## ITB # 201911 – MSV Trails

### Questions & Answers

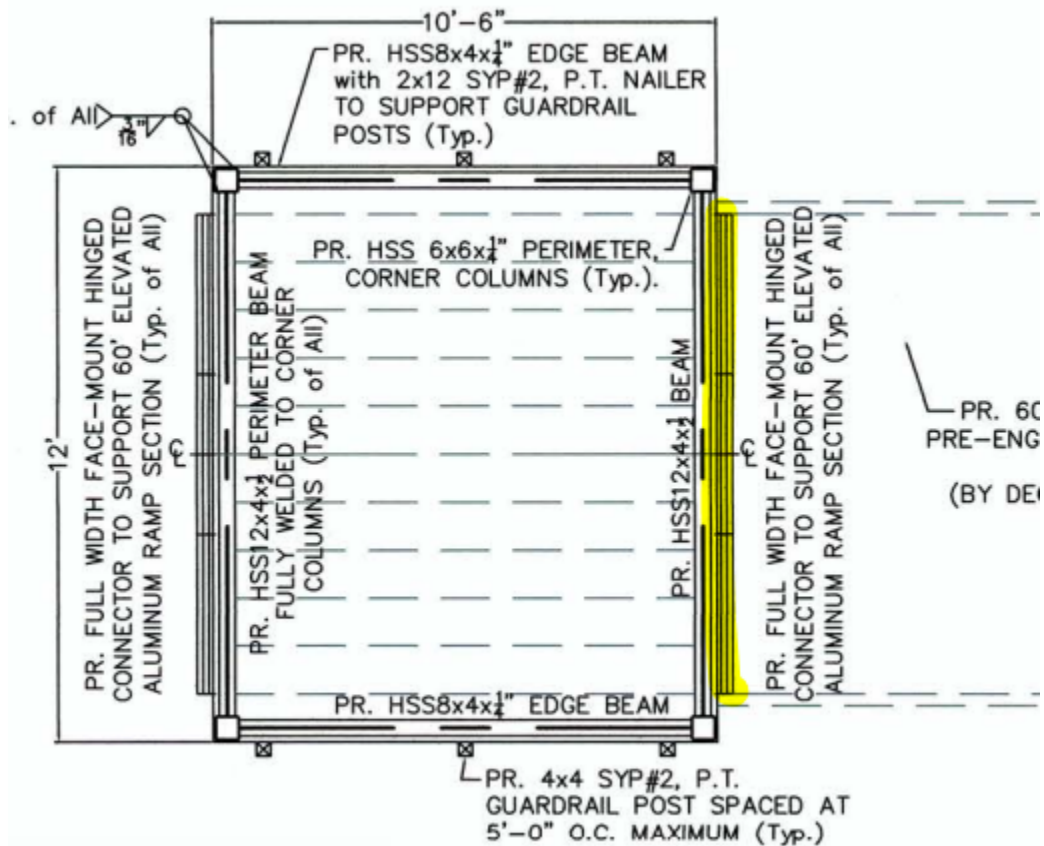
- Q9. Can the wetlands cleanup and trail locations be marked in the field?  
A9. The wetlands cleanup and floating walkways have been marked in accordance with the diagram below (note that since this was pasted into this document it is no longer to scale).
